**Fiscal Year 2015
Phased Construction Completion Report
for the Oak Ridge Reservation
Environmental Management Waste Management Facility**

DOE/OR/01-2683&D2

Date Issued—September 2015

Fig. 7. Status of disposal cells at the end of FY2014.

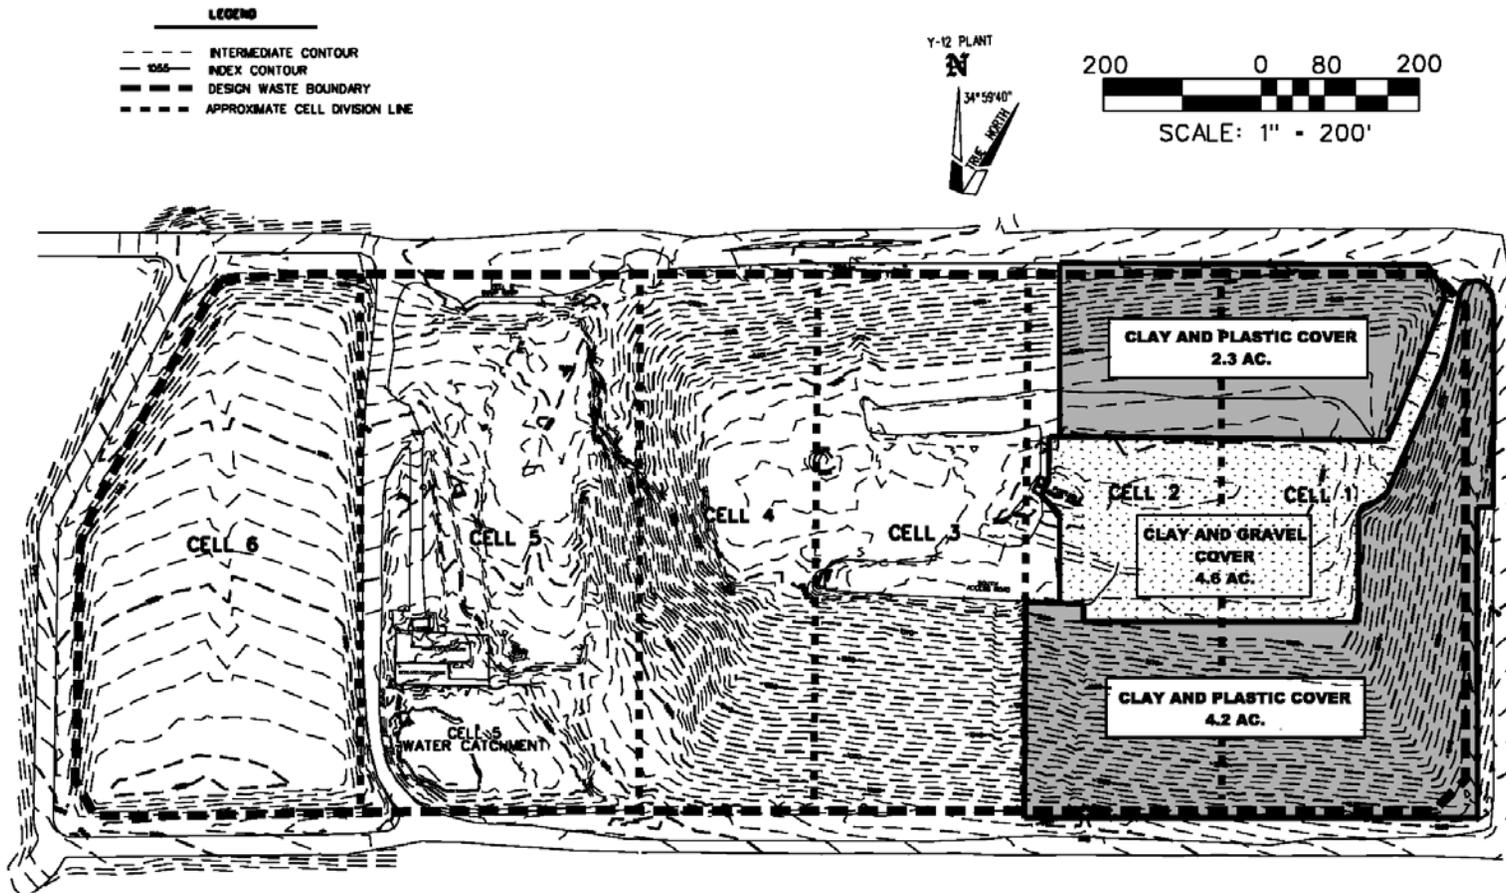
COMMENT NO.	SECT/ PAGE	COMMENT	RESPONSE
			employees with the highest potential for exposure. Personnel sampling results were all below the administrative action limit of 0.04 fibers/cc for a 10-hour day for asbestos fibers. Area samples were all below the EPA NESHAP limit of 0.01 fibers/cc.”
11	Figure 6 Status of Disposal Cells at the end of FY2014, Page 20	This figure shows clay and plastic cover over two areas encompassing 4.2 acres and 2.3 acres, and clay and gravel cover over 4.6 acres; however, the acreage depicted in this figure appears to be inconsistent with text in the D1 PCCR. For example, Table 9, Status of Enhanced Operational Cover, lists the area under enhanced operational cover and shedding water out of the landfill as 5.28 acres, and Section 3.8.1, Enhanced Operational Cover, indicates 3.9 acres of enhanced operational cover was added in Fiscal Year 2014, with the total acreage of enhanced cover totaling 5.28 acres. Revise Figure 6, Section 3.8.1 and Table 9 to address these apparent discrepancies.	Agree. Figure 6, Section 3.8.1, and Table 9 are correct. The following note has been added to Figure 6 to provide additional clarity: “The enhanced operational cover is present over 11.1 acres, of which 5.28 acres shed clean stormwater runoff out of the cells.”

Fig. 8-1. Groundwater and surface water sampling locations for groundwater detection monitoring.

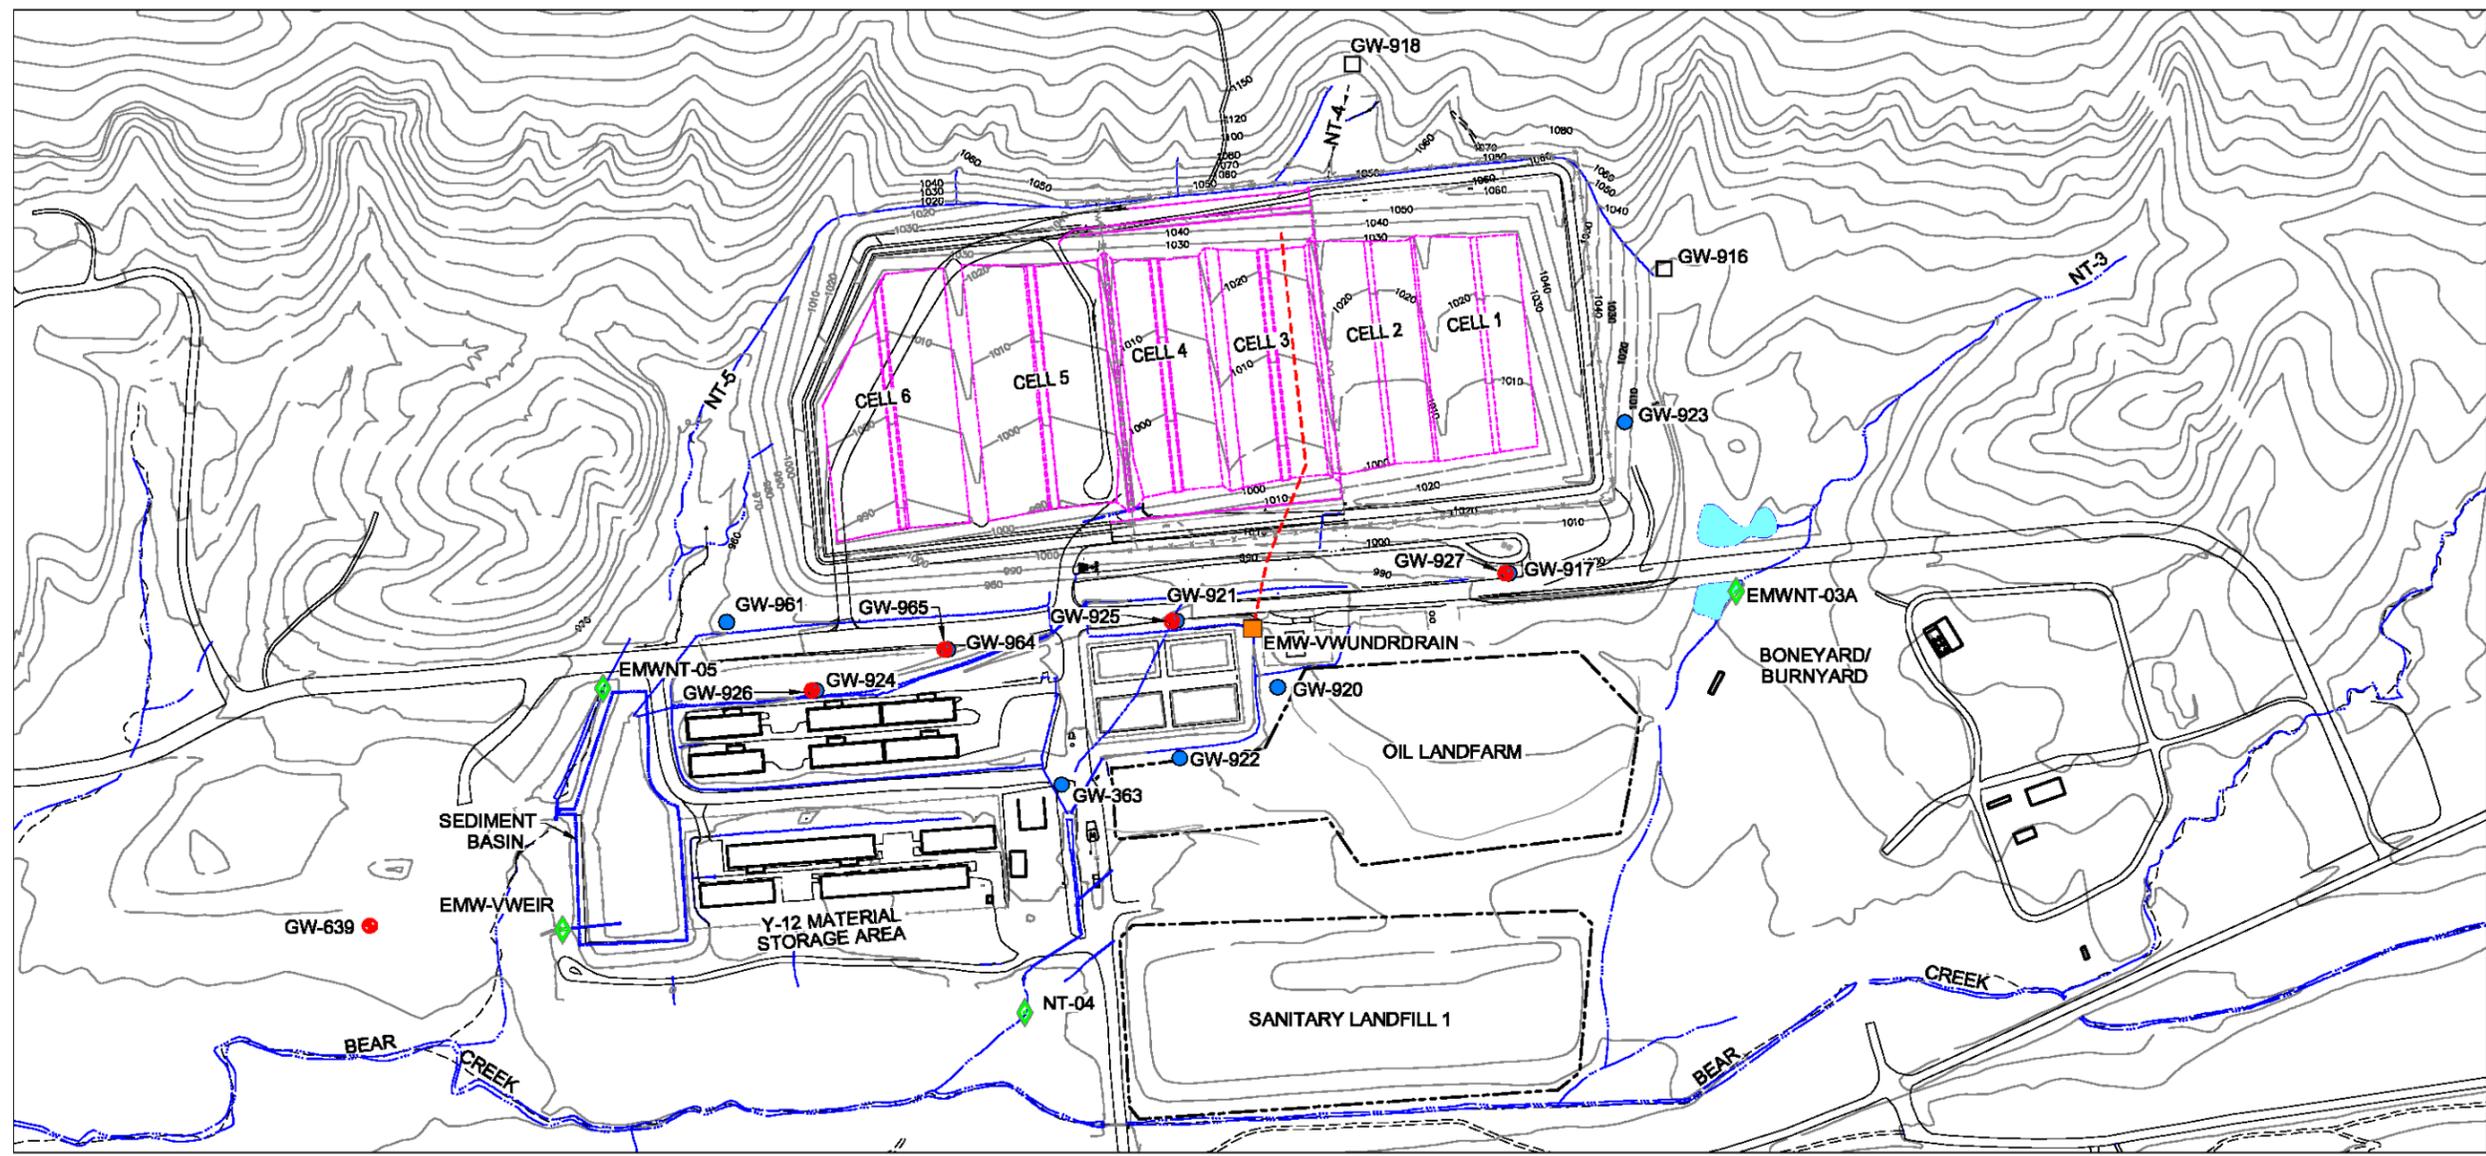
COMMENT NO.	SECT/ PAGE	COMMENT	RESPONSE
		<p>The same water elevations near PP-01 and PP-02 are along the Northeast east of Cells 1 and 2 as shown on Figure 8. Is the buffer elevation so much different there? Please explain and/or correct this statement.</p> <p><i>“Surface water complies with AWQC, except for low levels of dissolved oxygen in samples collected from stations NT-04, EMWNT-03A, and EMW-VWEIR during July 2014.”</i></p> <p>TDEC agrees AWQC are met at the compliance point at NT-5. However, pH does exceed the AWQC at the EMW-VWEIR at times. The process that best explains the observed pH exceedances at the VWEIR is that underwater photosynthesis exceeds respiration, so pH rises as carbon dioxide is extracted from the water. As the sun begins to set, photosynthesis decreases and eventually stops, so pH falls throughout the night as respiring organisms add carbon dioxide to the water. The daily interplay of respiration and photosynthesis caused pH to cycle up and down during a 24-hour period. Extended episodes of high pH are particularly common in ponds where filamentous algae dominate the plant community. Also, high pH in aquaculture ponds appears to occur more frequently and with greater severity in waters with low total hardness and moderate to high</p>	<p>1019.14, and 1017.20 respectively. The north end of Cell 1 is 3.45 feet higher than the same location in Cell 3. The elevated water level measurements are localized to the upper northeast area of the EMWMF.</p> <p>Agree. See response to comment #11. The text has been revised as follows: “Surface water complies with the currently required AWQC. However, pH and low levels of dissolved oxygen exceed AWQC at times. These exceedances are expected to be related to algae growth in the Sediment Basin.”</p>

Fig. 10. Generalized directions of groundwater flow in the uppermost aquifer at EMWMF (August 2014).

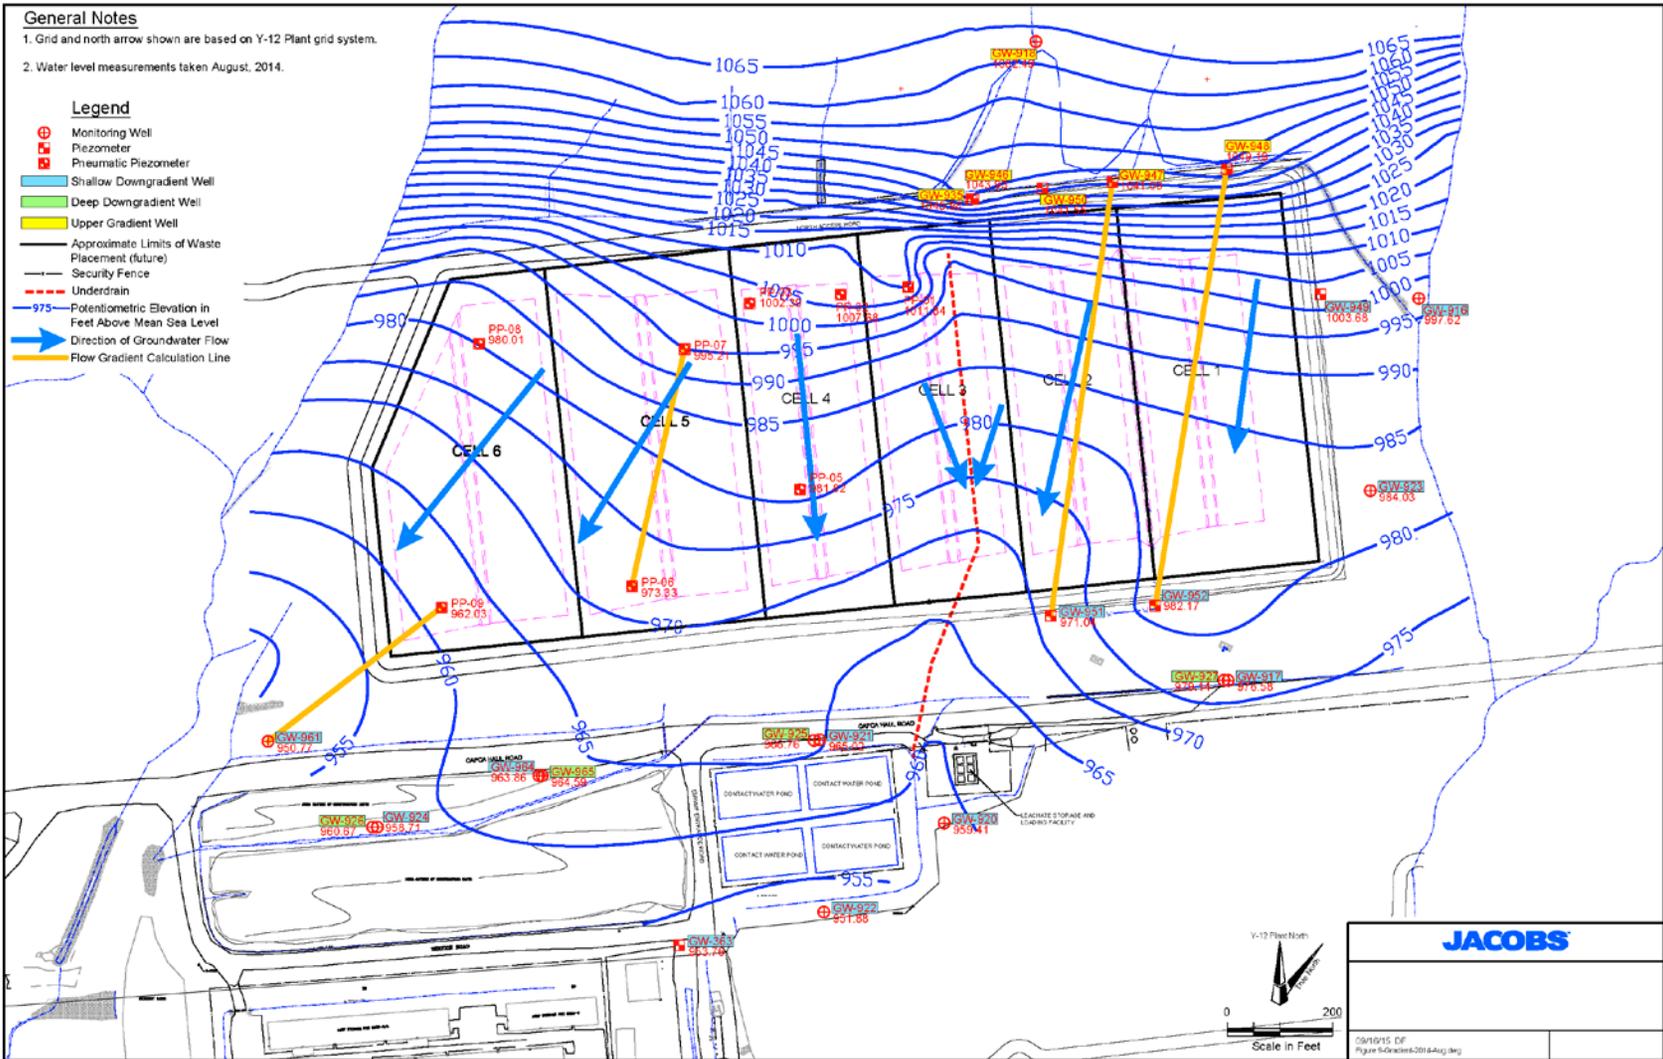
COMMENT NO.	SECT/ PAGE	COMMENT	RESPONSE
		the potential for a component of groundwater flow that may be migrating along preferential flow paths laterally from Cells 1 and 6.	TDEC.
16	Figure 8, Generalized directions of groundwater flow in the uppermost aquifer at EMWMF, Page 33	This figure includes outdated groundwater flow data. Specifically, the figure references water level measurements from February 2012. Further, Section 5.3.2, Groundwater Flow Direction and Rate, discusses seasonally wet conditions (February 2014) and seasonally dry conditions (August 2014) and references Figure 8; however, Figure 8 does not include this data. Revise Figure 8 to present current groundwater flow conditions. In addition, present separate figures that depict seasonally wet and dry conditions.	Agree. Figure 8 has been revised to reflect current data.
17	Section 5.3.3, page 35	The indicator contaminants in the EMP are in the reference list as the latest version. Please identify the latest version of the EMP in the reference list. Confirm whether it has been approved for inclusion in the list of FFA approved Primary Documents.	Clarify. As discussed with the Project Team, the revision of the EMP that was the basis of this PCCR is dated August 2011. This reference has been updated, to indicate the date.
